As per our discussions of last week, please find included prints that reflect changes requested.

The prints show changes to the rear deck from 15 feet to 22 feet.

SITE PLAN
192 RESERVOIR STREET
MARLBOROUGH, MA

1st floor plan

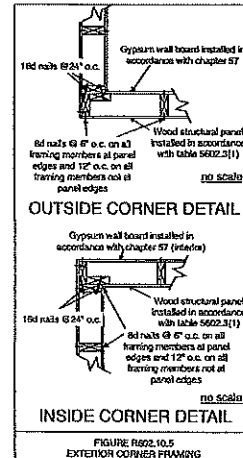
changed To 22'x10' Deck

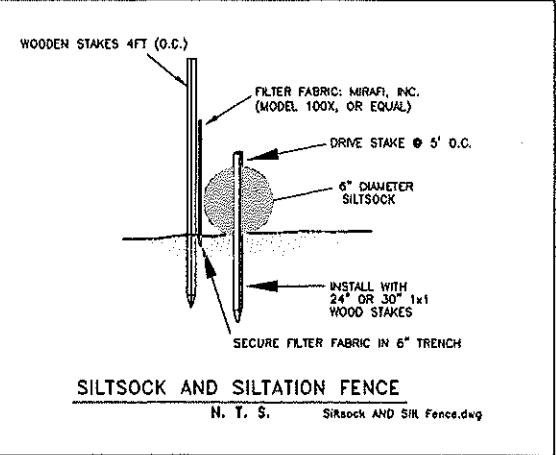
STAIRS shifted 4' → Deck 10'x22' All Deck helicoils 7(was 6) approx 11' from Fdn wall
